ORIGINATION FORM

Proposed Revisions to a Standard Plans Index
(Please provide all information – Incomplete forms will be returned)

Index Number: **18300**
Sheet Number (s): All
Index Title: Dynamic Message Sign Walk-In

GENERAL LAYOUT

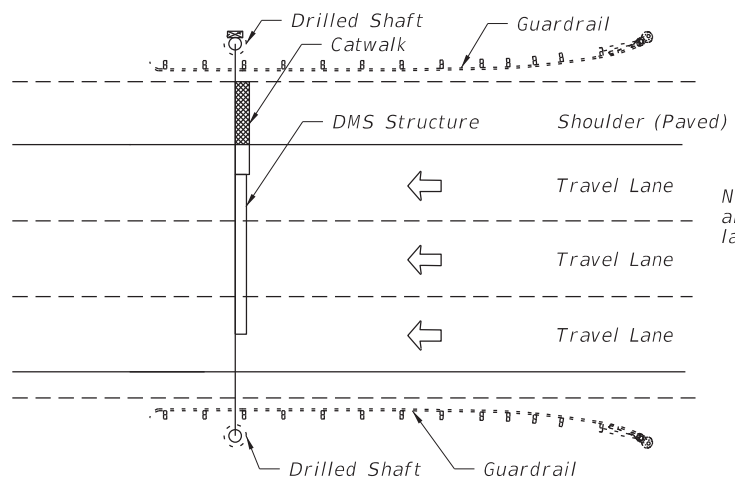
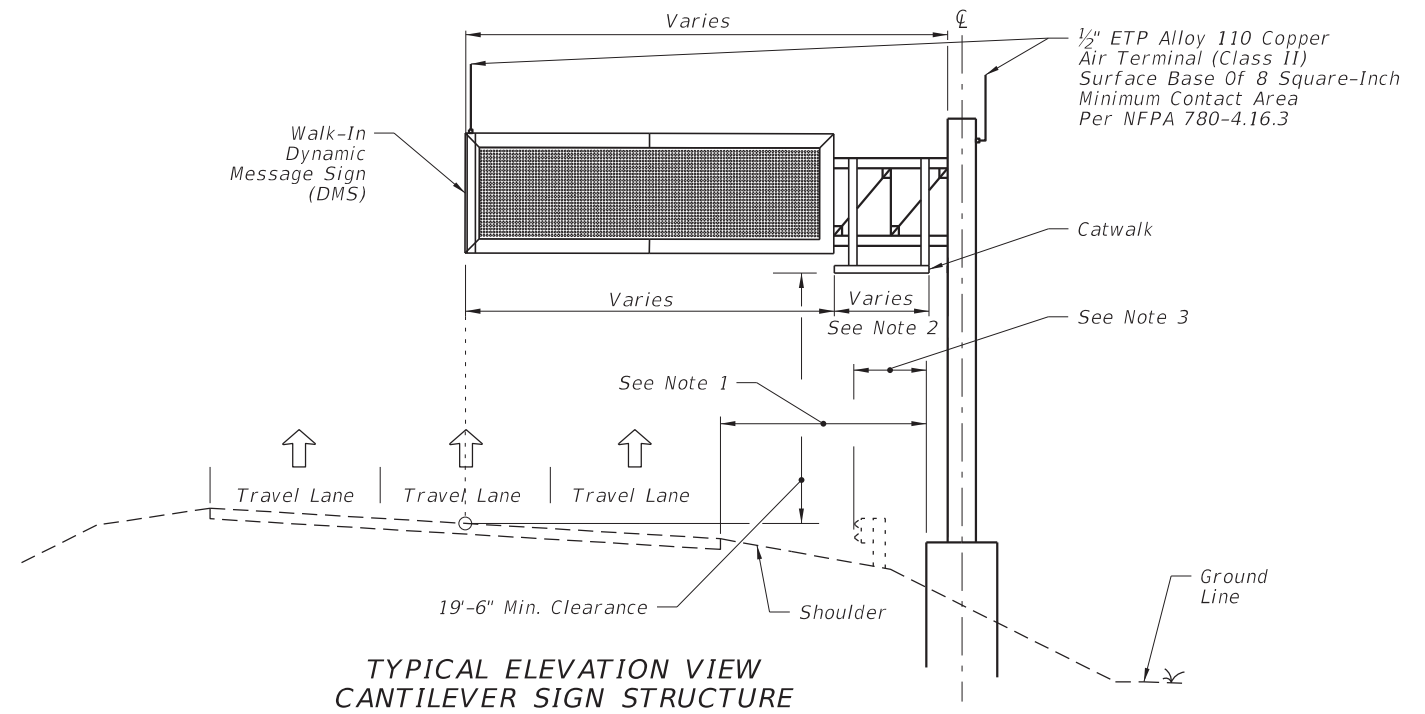
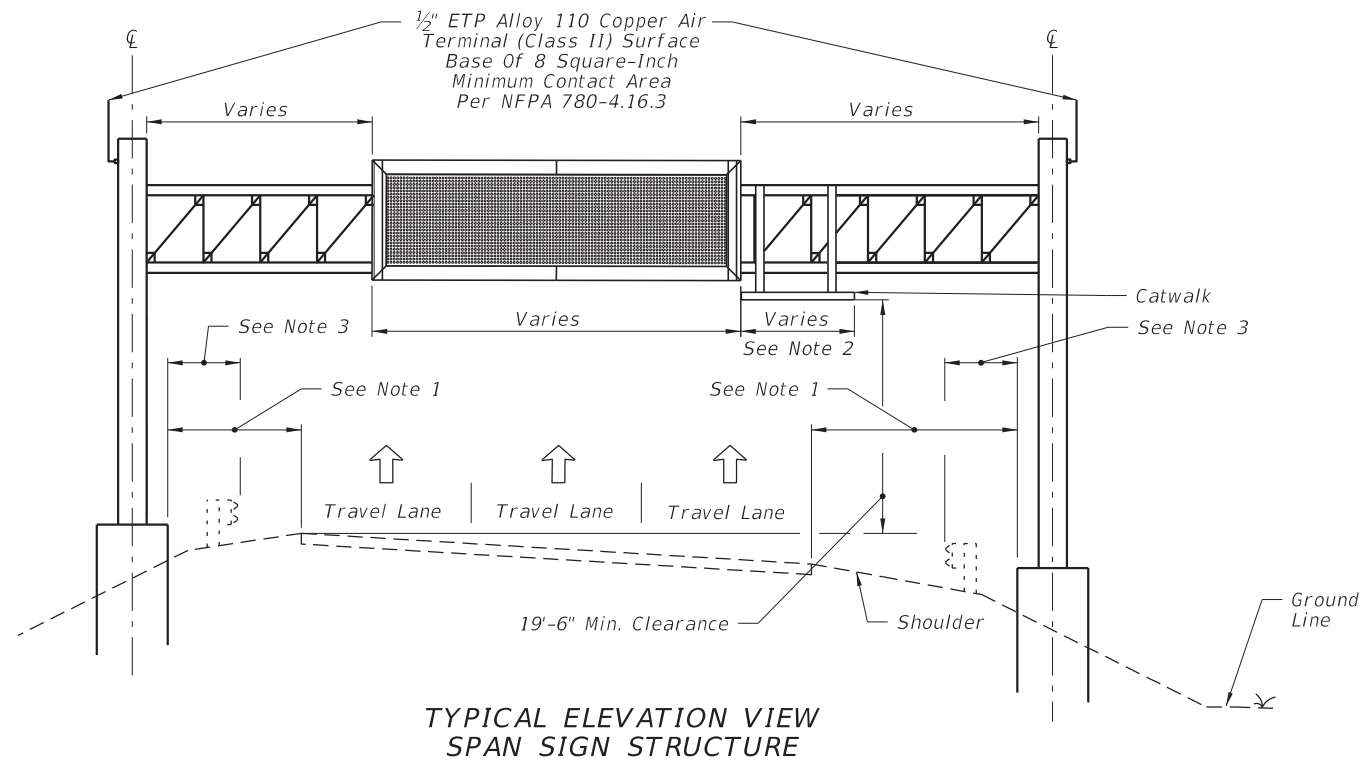
REDEVELOPED INDEX

RENUMBERED ALL

CHANGED ALL
11/01/17

CHANGED ALL
700-090

SIGN AND CABINET WIRING DIAGRAM

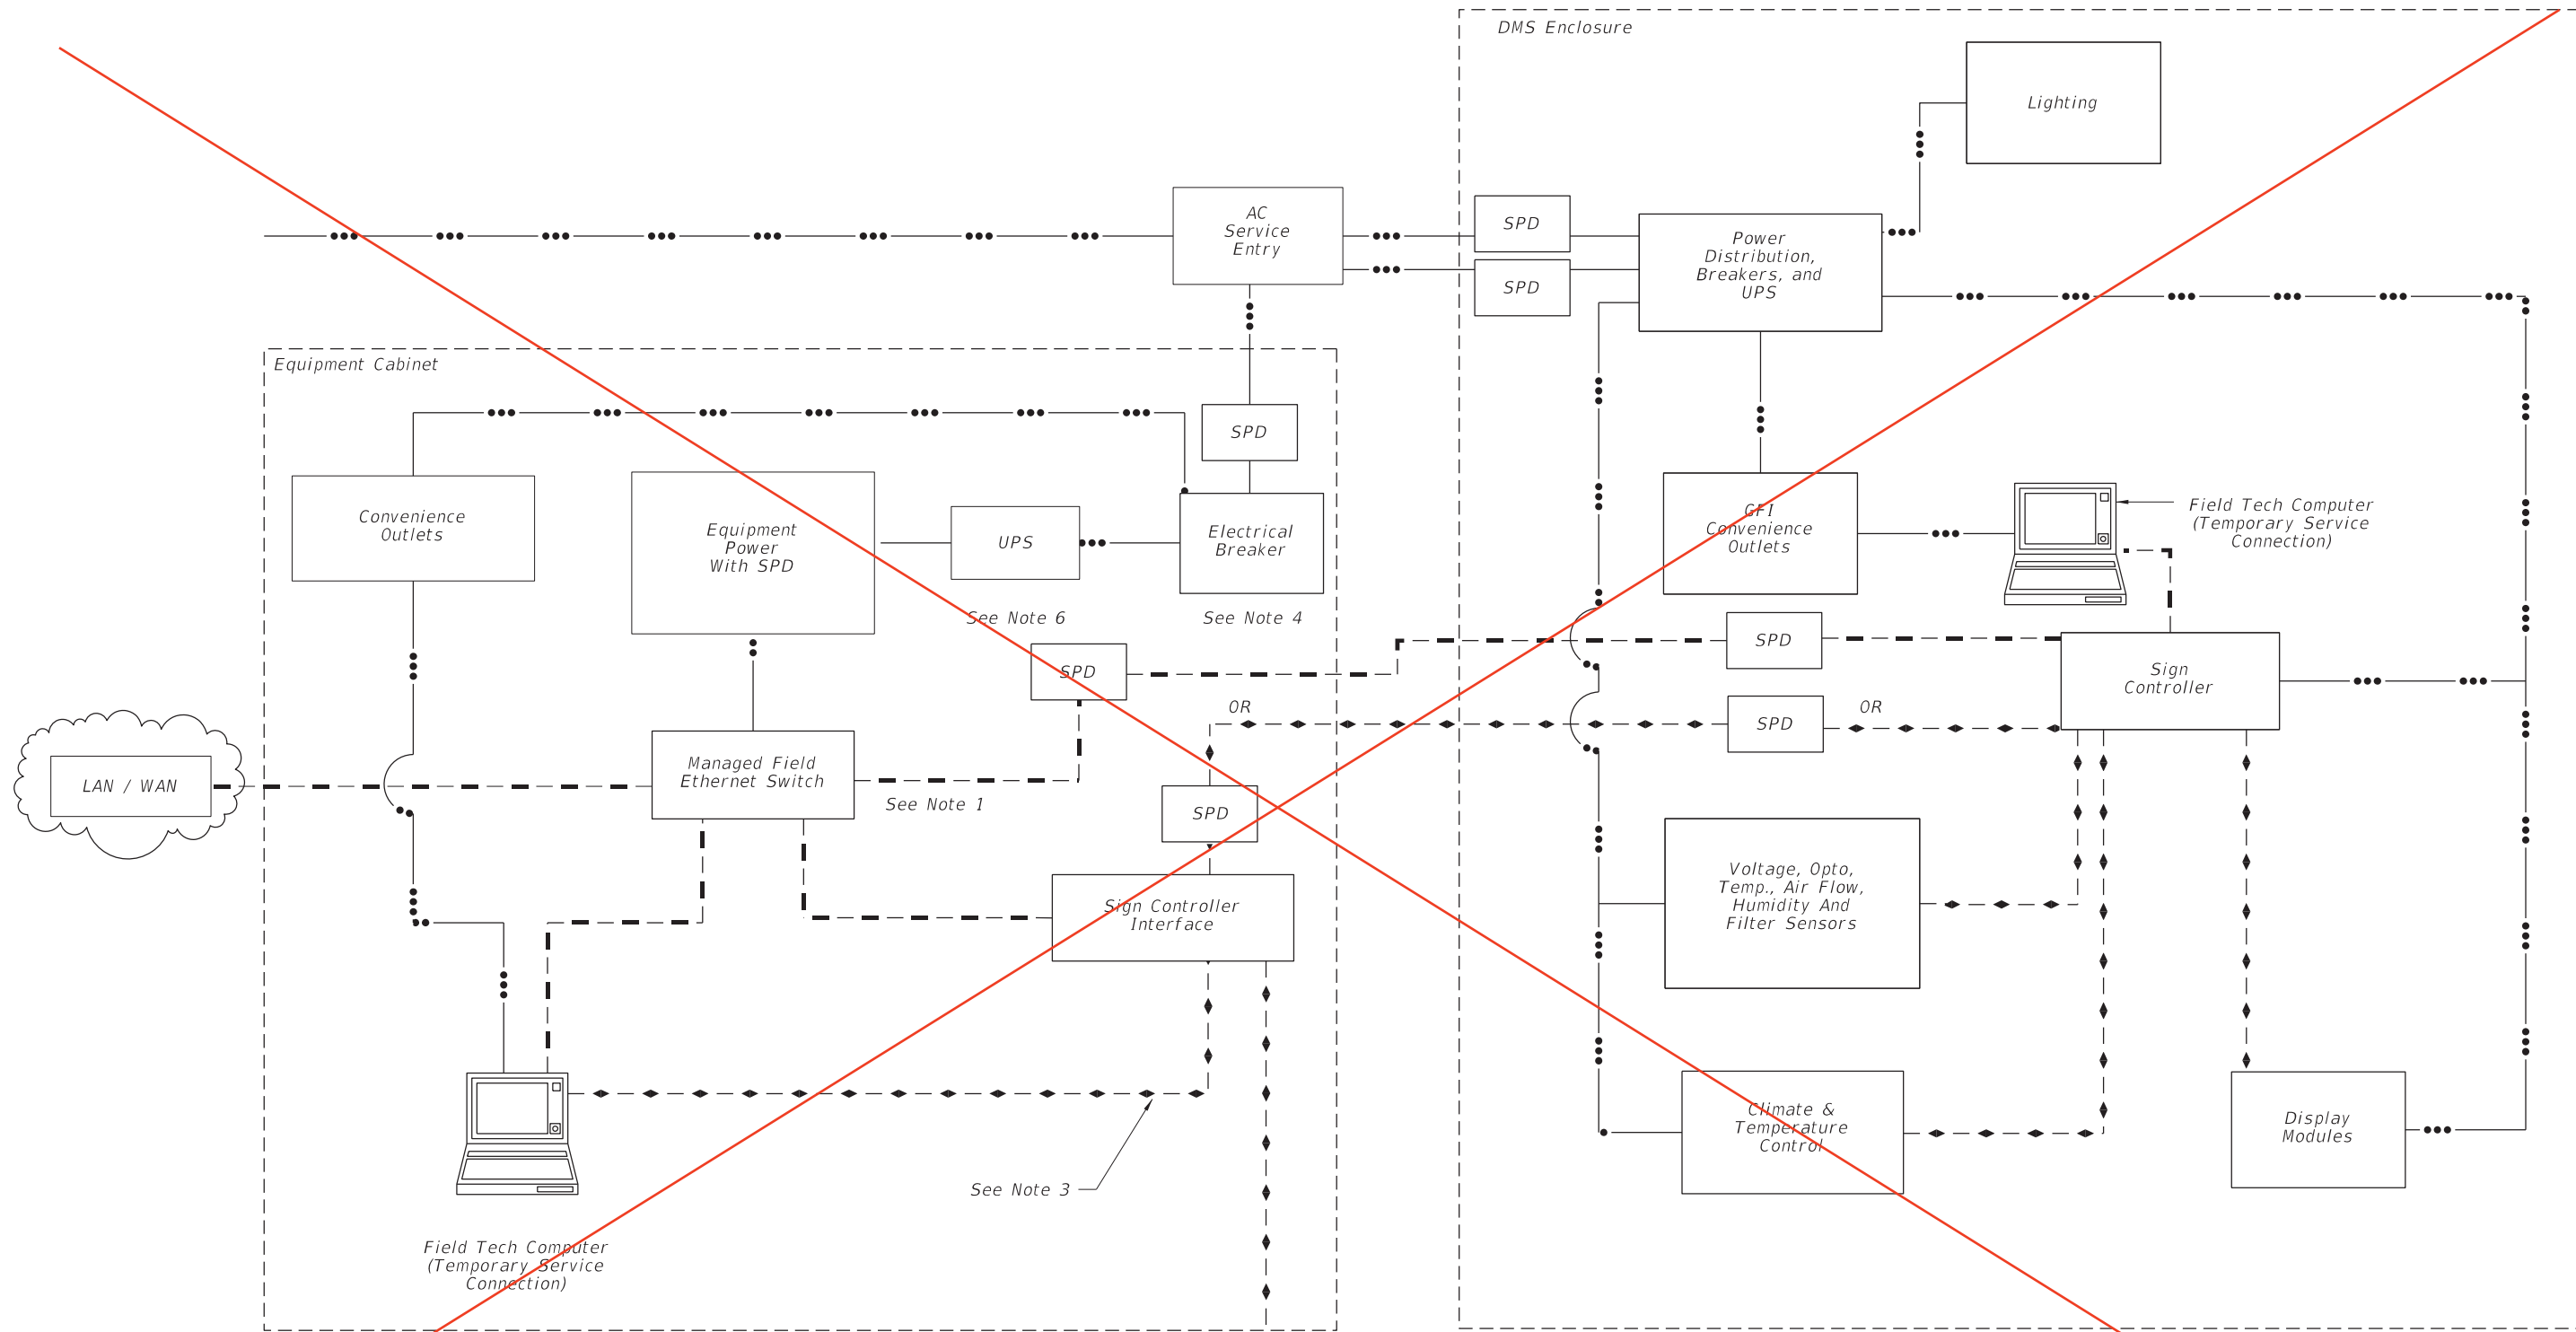
DELETED SHEET

CABINET LAYOUT 1

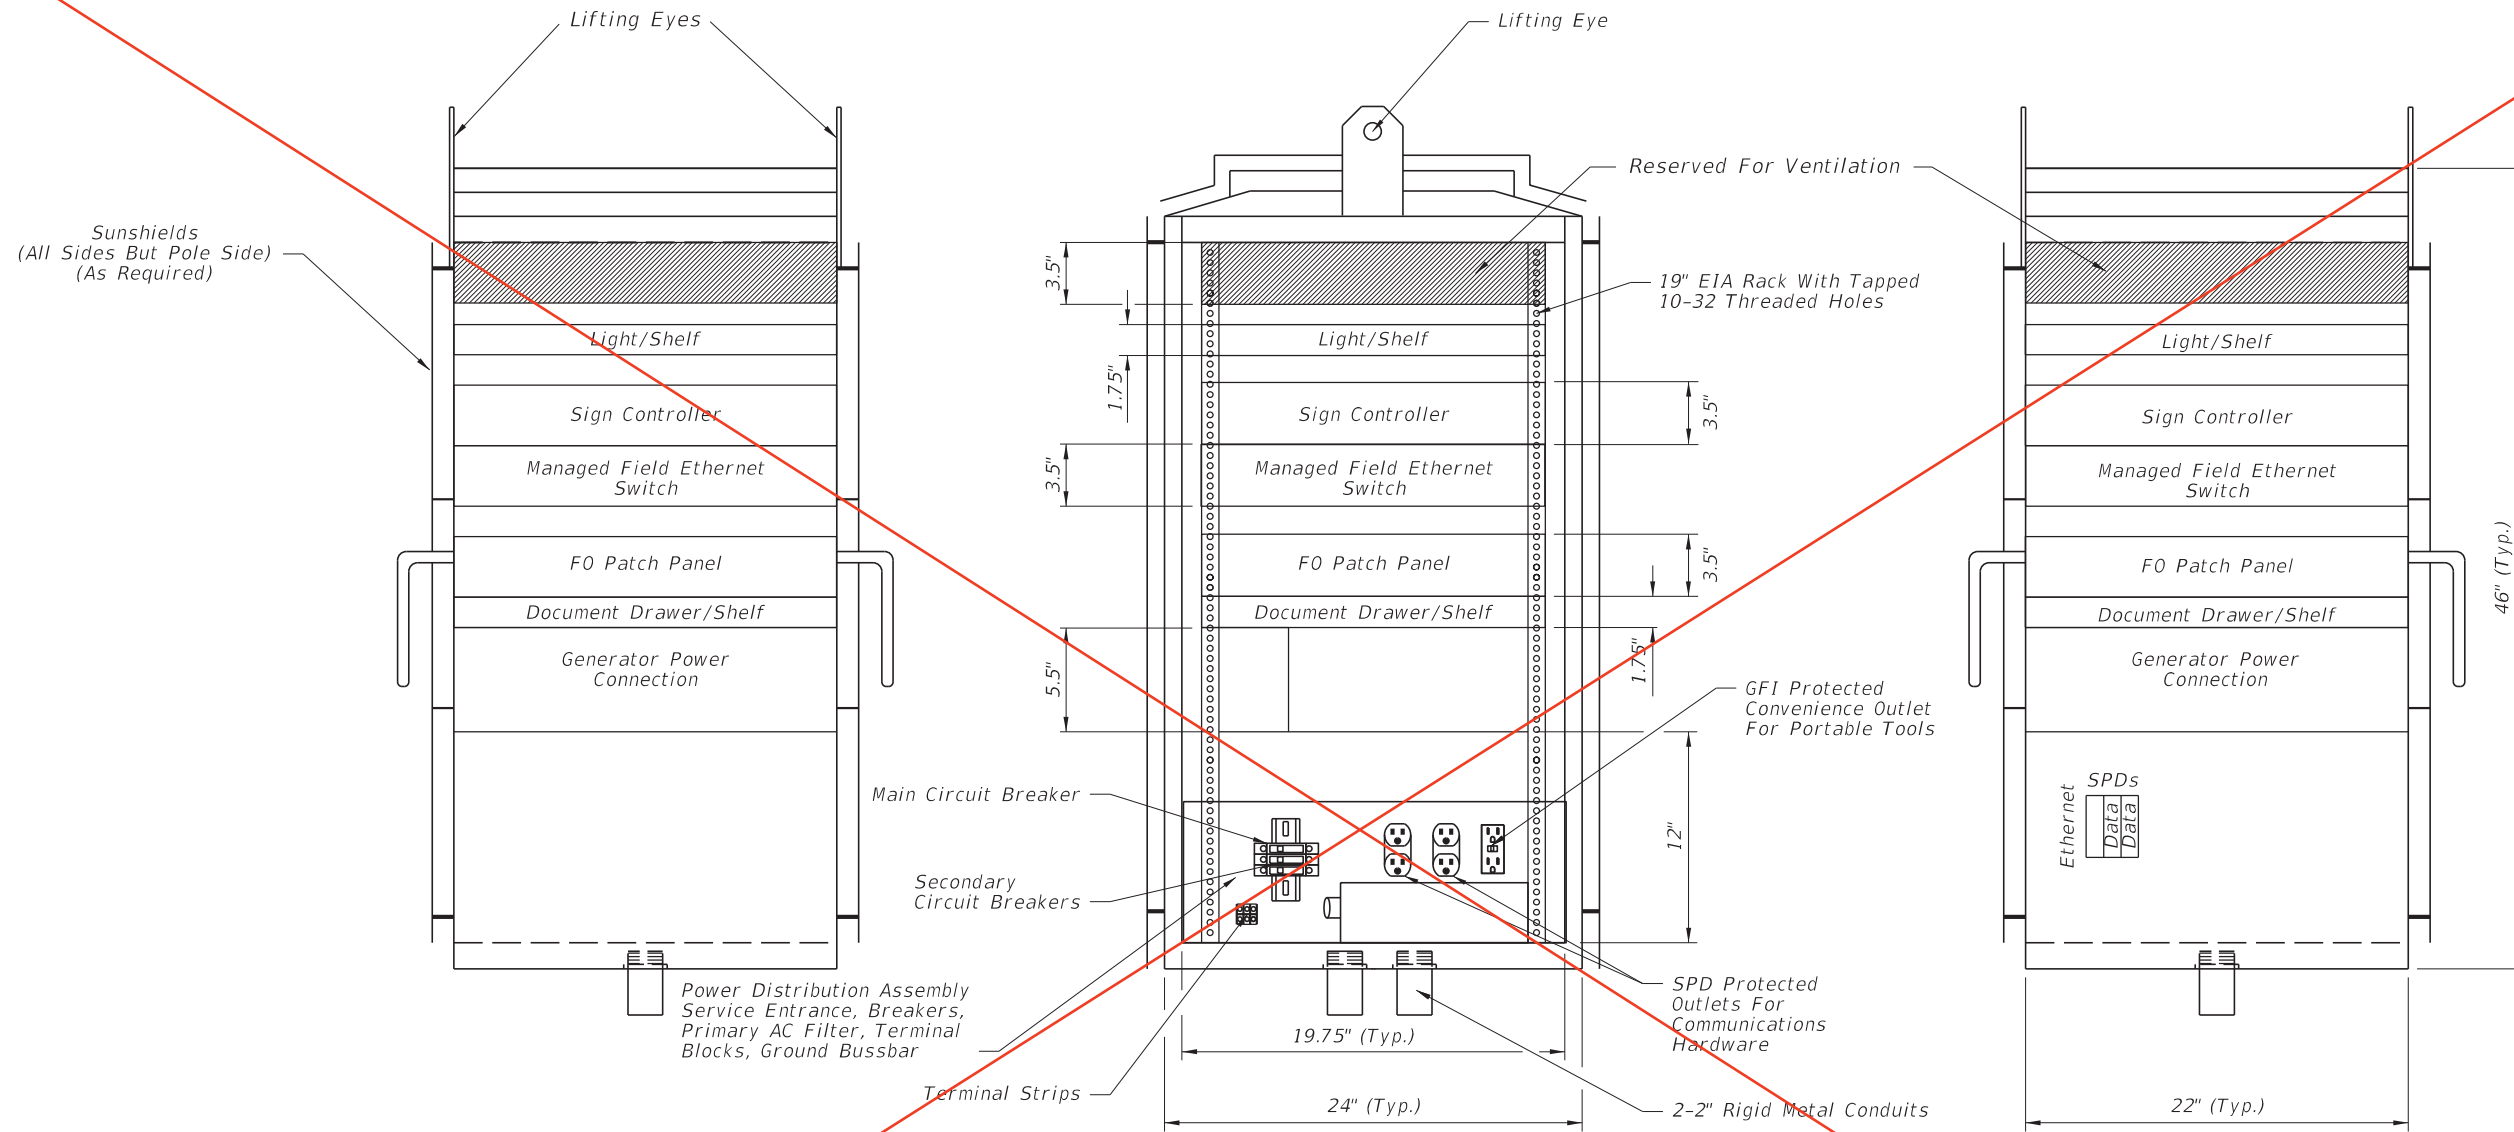
DELETED SHEET
